# TECHNICAL MEMO

**To** Linda Riley**From** Biljana Rajlic**Date** July 11, 2012**Project #** 285380**Reference** Tunnel watertightness**Page** 1 of 16**CC**

## PART 2 – RESPONSE TO HMQ COMMENTS

**Figure 1: Drains in a typical WEP tunnel abutment**

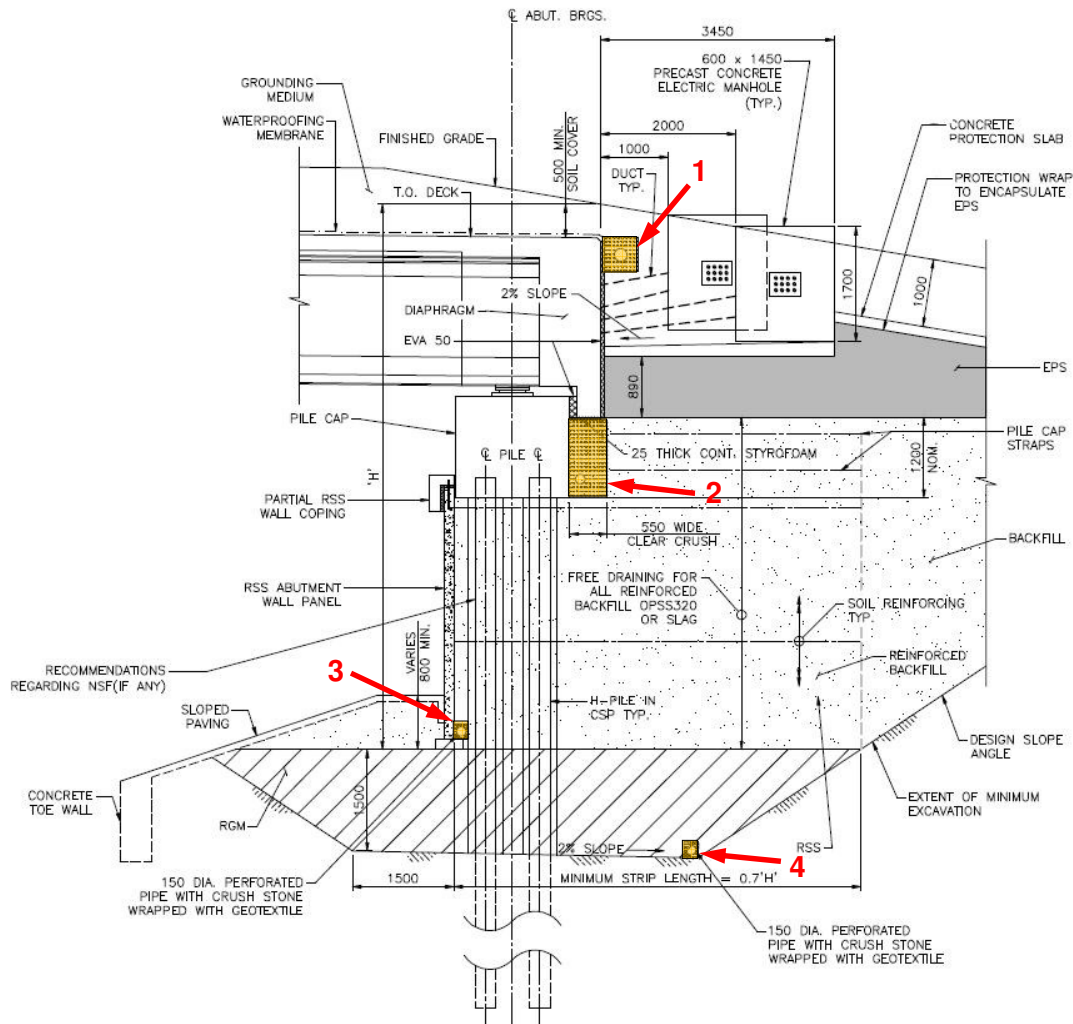
HMQ comment: "HMQ would consider the four (4) lines of subdrains identified in Section 4 of PIE's memo (enclosed with PIC's letter) on their own to be non-compliant as the EPS could act as an impervious layer thus causing water to build up behind the abutment."

1. HMQ would consider the four (4) lines of subdrains identified in Section 4 of PIE's memo (enclosed with PIC's letter) on their own to be non-compliant as the EPS could act as an impervious layer thus causing water to build up behind the abutment. Please propose a solution to address this issue.

Since the issue of revision A of this memo, the precast concrete manholes have been removed from this location. The removal of the electrical manholes means that there is no longer the potential for water to be trapped in the lowered portion of EPS, as was shown in Figure 1 of revision A.

Figure 3: Layout of drains in a typical tunnel. Abutment drains have outlets to the storm sewer catchbasins, which are indicated here as green squares.

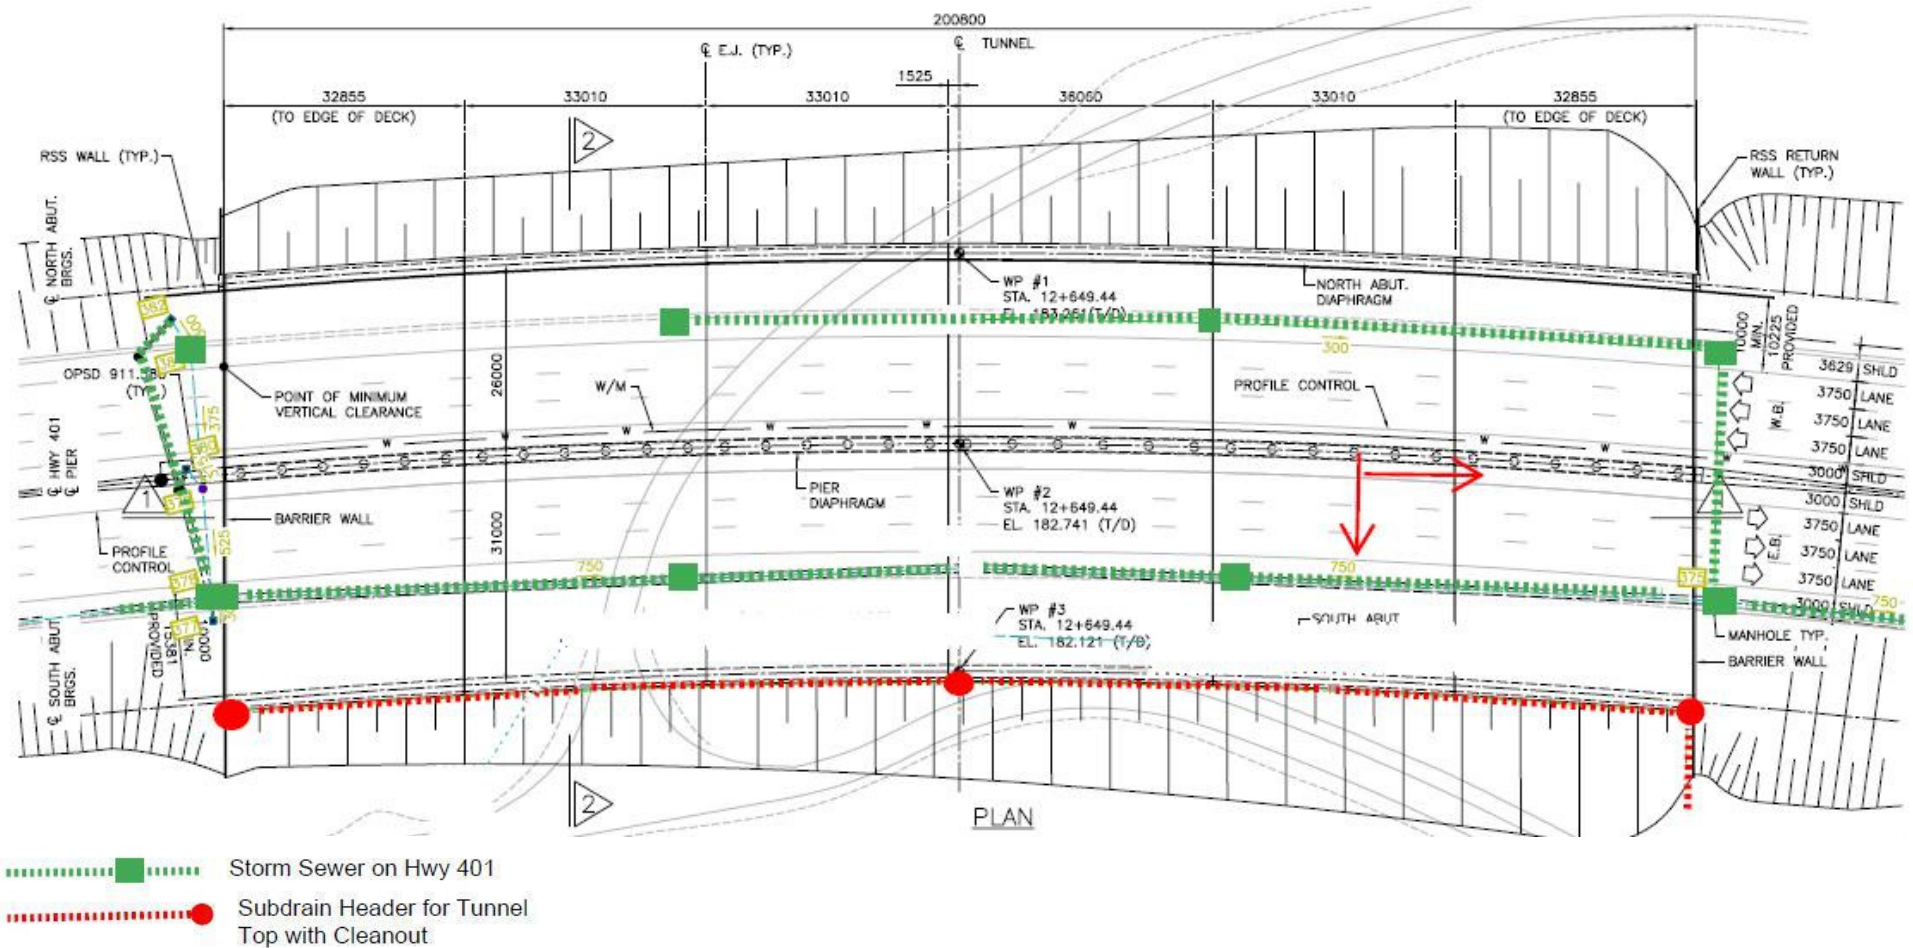
HMQ comment: "...As each of the 5 lines of subdrains has a specific purpose for the drainage of a specific area of the structure, the subdrain system may not provide sufficient redundancy in the event that one or more pipes become blocked. WEMG should propose a means of monitoring the performance of the subdrain system and removing any plugs. Further detail should also be provided for the "Cleanouts" shown in Figure 3."

3. With respect to the 5th paragraph in Section 4 of PIE's memo, the term 'well-graded material' infers some percentage of fines, which can clog the subdrains. As each of the 5 lines of subdrains has a specific purpose for the drainage of a specific area of the structure, the subdrain system may not provide sufficient redundancy in the event that one or more pipes become blocked. WEMG must propose a means of monitoring the performance of the subdrain system and removing any plugs. Further detail should also be provided for the "Cleanouts" shown in Figure 3 of the memo.

WEMG is of the opinion that the subdrain system will provide sufficient redundancy in the event that one or more pipes become blocked. The system is to be installed according to the requirements of OPSS 405, including wrapping the subdrains with a knitted sock geotextile, and the subdrains will have sufficient slope for the water to drain properly.

Inspection of the subdrain outlets will be part of the detailed structures inspection that is specified to happen every year.

Further detail for the "Cleanouts" has now been provided in the Highways design submissions. Typical details are shown in Figure 9.

Figure 10: Plan on abutment joint seal (extract from Structures design submission)

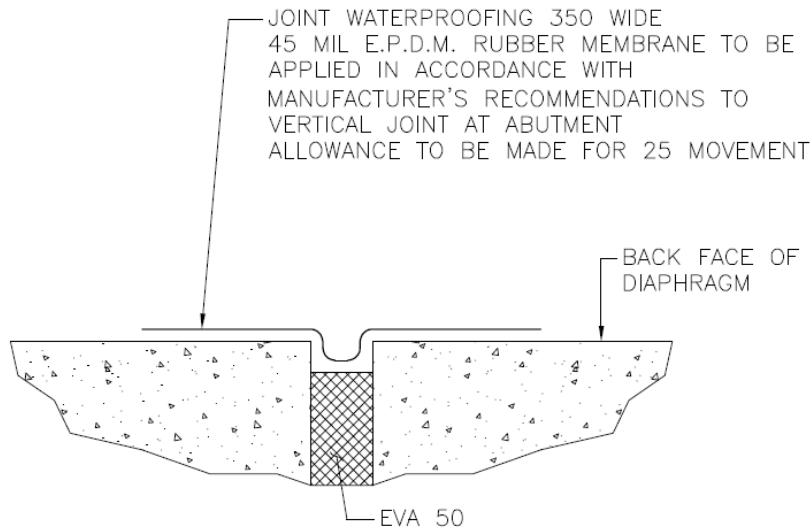
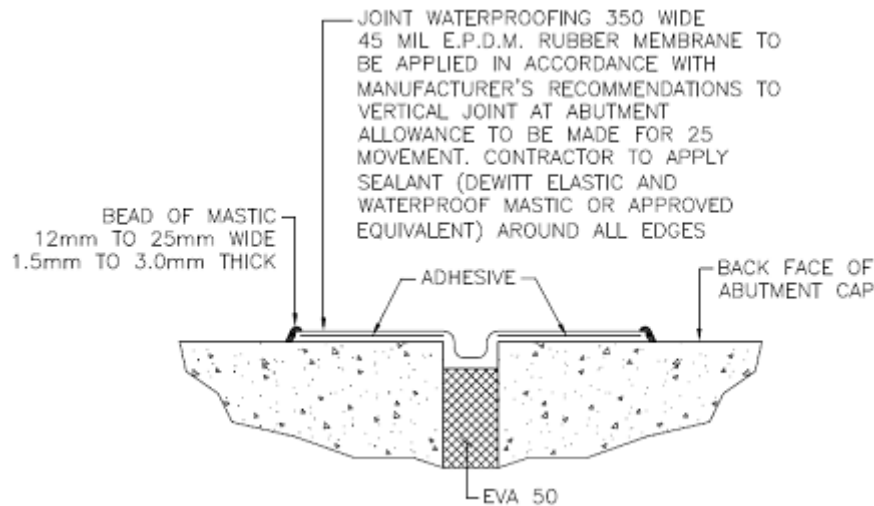
HMQ comment: "...the edges of the rubber membrane should be sealed to prevent the ingress of water between the concrete and the membrane."

4. The proposed details at abutment joints referenced in Section 5 of PIE's memo are in general conformance with OPSD 3950.100, November 2005. The only comment to be directed to WEMG with respect to the abutment joints is that the edges of the rubber membrane should be sealed to prevent the ingress of water between the concrete and the membrane.

- 5) We have concerns with the expansion/contraction joint detail and revisions to the proposed design are required. Some concerns include the possibility the EPDM being torn due to movement and the likelihood for deleterious material to migrate between the E.P.D.M and EVA due to the presence of a gap.

WEMG fully agrees with this comment, and Tunnel drawings will specify that the rubber membrane be fully sealed to the concrete surface with an appropriate adhesive system around all edges, as shown in Figure 10.
